ZONING CHANGE REVIEW SHEET

CASE: C14-2020-0151 – 8401-8407 South 1st Street DISTRICT: 2

ZONING FROM: DR; SF-2; SF-6-CO; LR-MU-CO ZONING TO: MF-4-CO

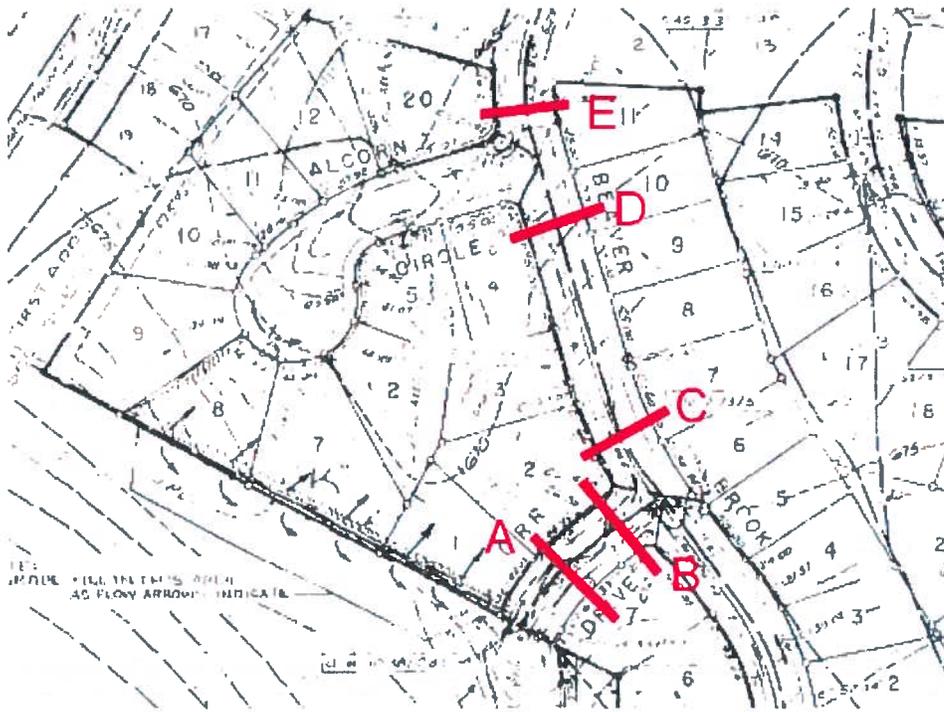
I received one drainage-related question from a Zoning and Platting Commissioner. Could you please provide a response (to the extent possible) prior to Tuesday at 10 a.m.?

The attached drainage area map shows the drainage for the proposed site at 8401 S 1st. Currently the site drains directly into the residential houses to the north. The proposed development, which you can see highlighted on the second sheet, is currently proposing to capture all flows and release them into the right of way on Orr Drive. This will completely take drainage off of the residential lots that drains directly onto their properties. They also propose to decrease the total flow that drains through their site. However, the site proposes to increase flow at Orr Drive which would require a waiver. As part of the drainage criteria manual requirements, there should be no increase in point discharge from any point of the development. The engineer has met with a few different members of staff to discuss possible solutions and over-detaining did seem to be the most feasible option as the City doesn't have proposed upgrades in this area.

EXISTING DRAINAGE AREA MAP

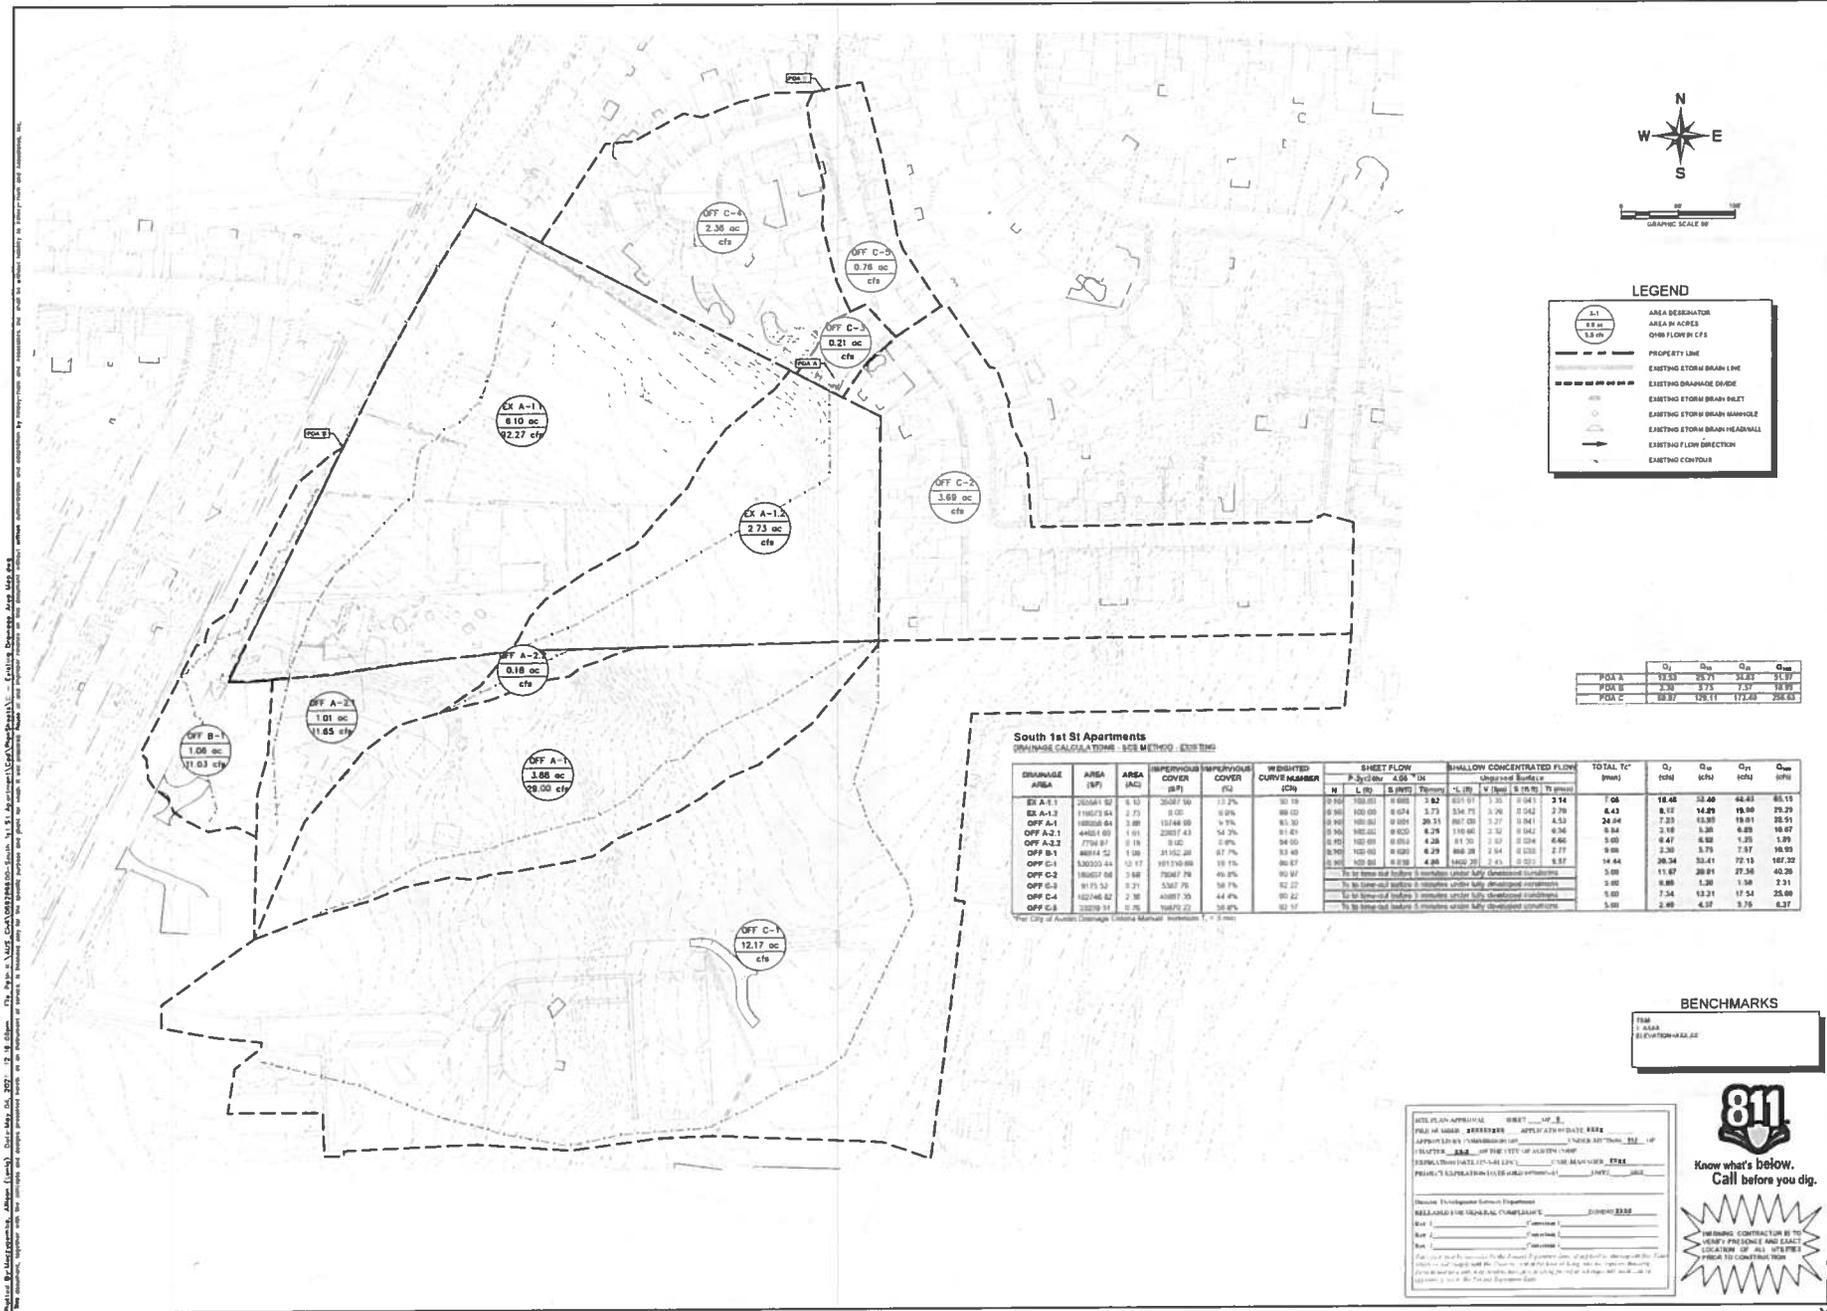
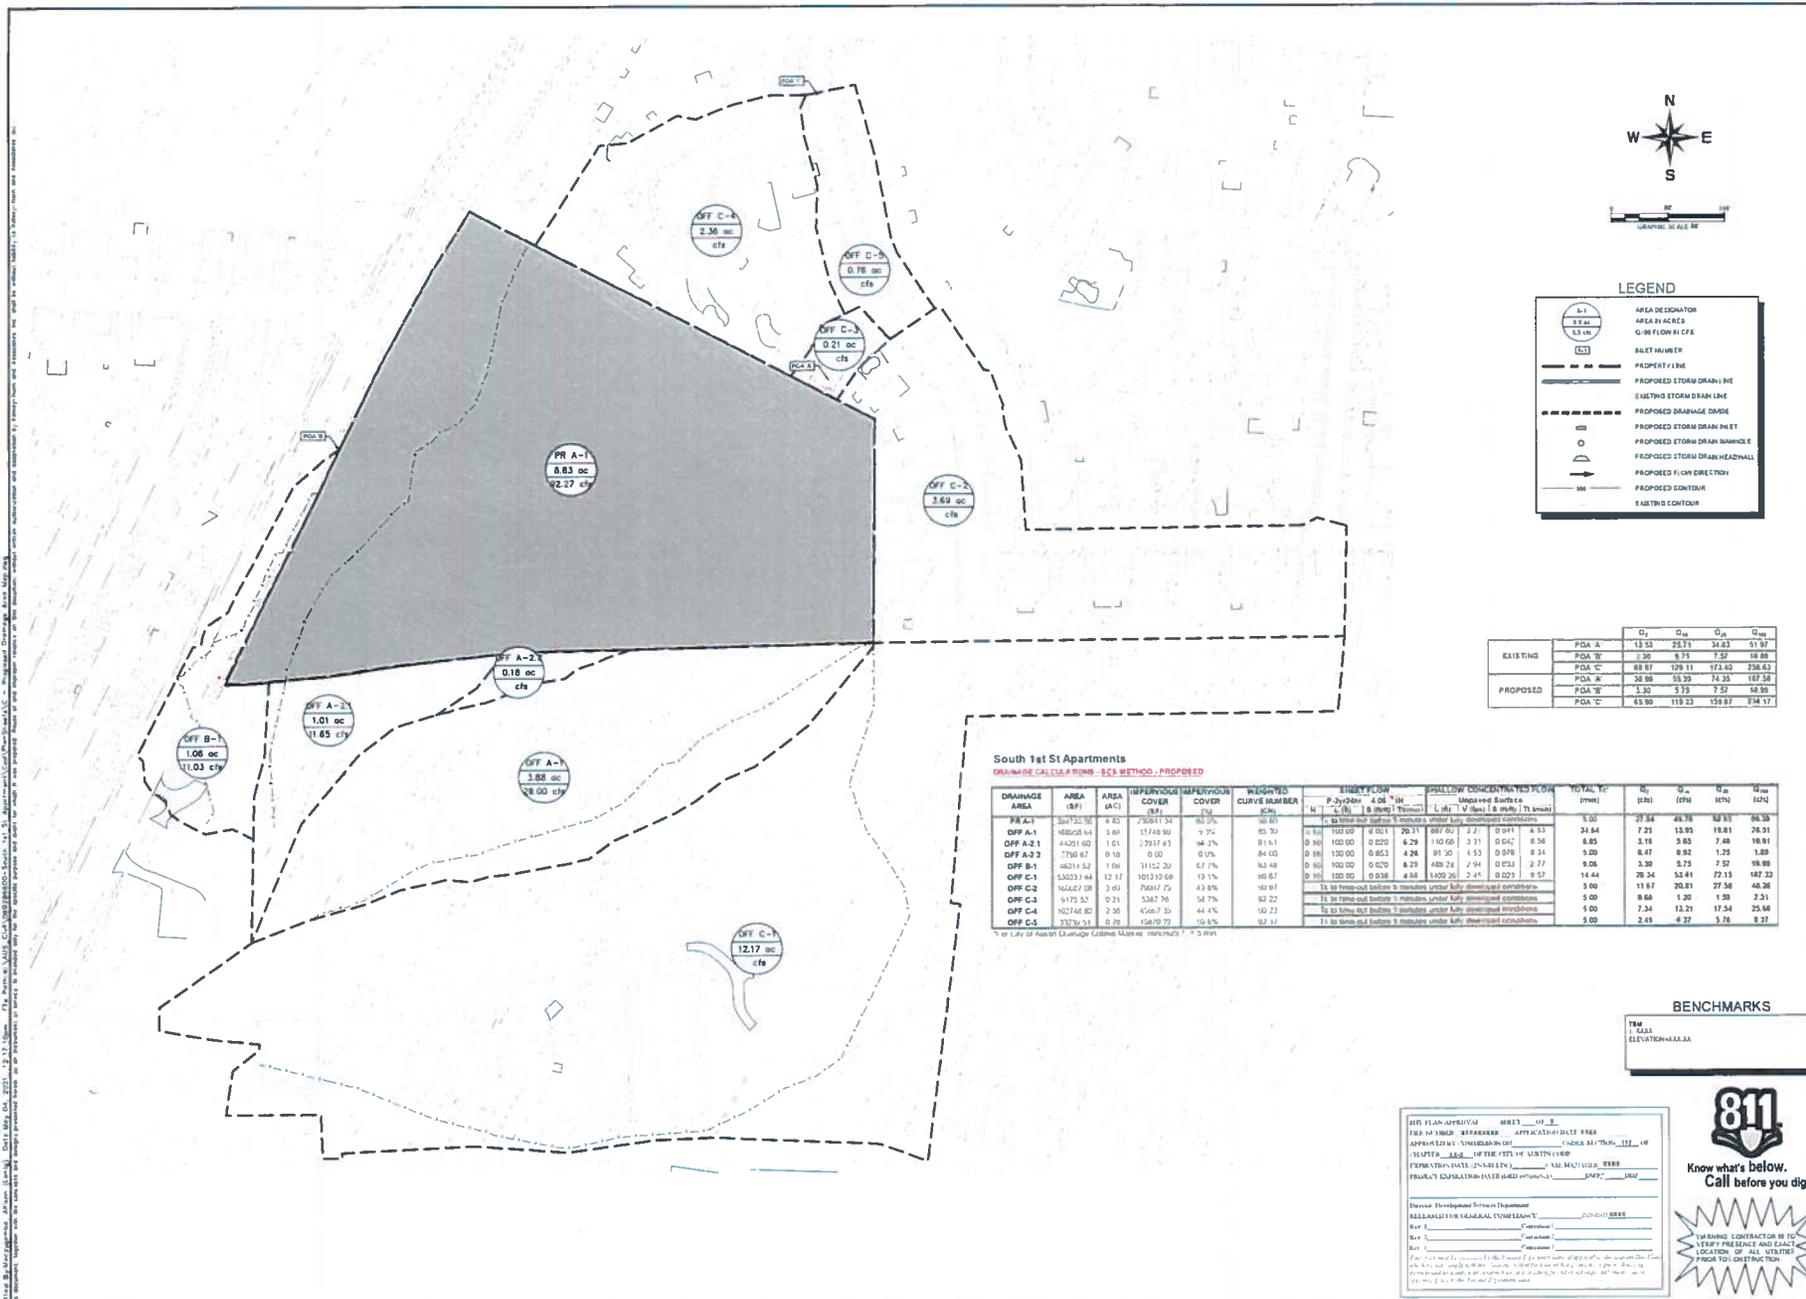
8401 S. 1st Street (#C14-2020-0151) Questions for City Staff – ZAP Comm. H. Smith

- a. Regrade. Regrade the site along the north and east property lines and construct a retaining wall system at the perimeter to prevent water from sheet-flowing onto neighboring properties. The retaining wall system consists of a rock wall approximately 3' in height, with a 6' solid wood fence on top (total of 9' high).

- b. Reroute. Provide a drainage easement along south and east property lines to redirect and slow sheet flows that are otherwise traveling unabated across the subject property.

- c. Improve Orr Drive inlet. Rework existing inlet at Orr Drive and provide a level-spreader that will limit stormwater within the right-of-way, thereby preventing it from surging onto neighboring homeowners properties during a 100-year flood event.

- d. Overdetain. Construct a subterranean detention pond onsite that is oversized more than required by City Code to capture on-site flows, in addition to reducing current off-site peak flow rates by 10%.

Please comment as to whether the above drainage improvements address existing drainage issues and will improve the existing drainage condition experienced by neighbors located adjacent to the Property along Orr Drive and Beaver Brook Lane.
